#### Service Bulletin 14

(a)Service Bulletin No.:	14
(b) Revision / Date	Revision 0 - 12 June 2006
(b)Title:	Colt Propane Cylinders - Liquid off-take fitting inspection
(c)Description:	Detailed visual inspection of weld at the base of the liquid off-take fitting.
(d)Applicability:	All hot air balloon types and variants where Colt V20,V30,V40,H20,H30,H40,H55 propane cylinders are fitted where the liquid off-take incorporates an integral mounting flange for a Quick Shut Off (QSO) system. All Thunder & Colt Hot Air Airship types and variants as above.
(e)Effectivity:	All CN's

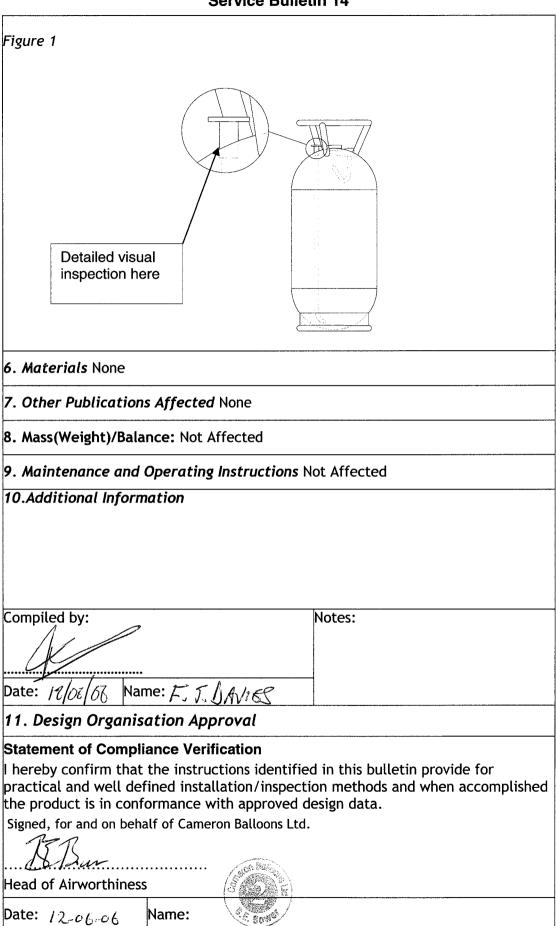
A crack has been found at the outer edge of the weld at the base of the liquid off-take fitting of a Colt V30 Propane Cylinder (manufactured in 1986).

- 1. Detailed visual inspection of cylinder(x5 magnification with suitable light source) through 360° at weld between cylinder shell and QSO mounting flange. Refer to Figure 1.
- 2. Reject any cylinder showing signs of cracking.
- 3. Report any rejections to Cameron Balloons Ltd.
- 4. For cylinders that have not yet been pressure tested in accordance with the 10-year periodic inspection programme, perform the periodic inspection at the next annual inspection.
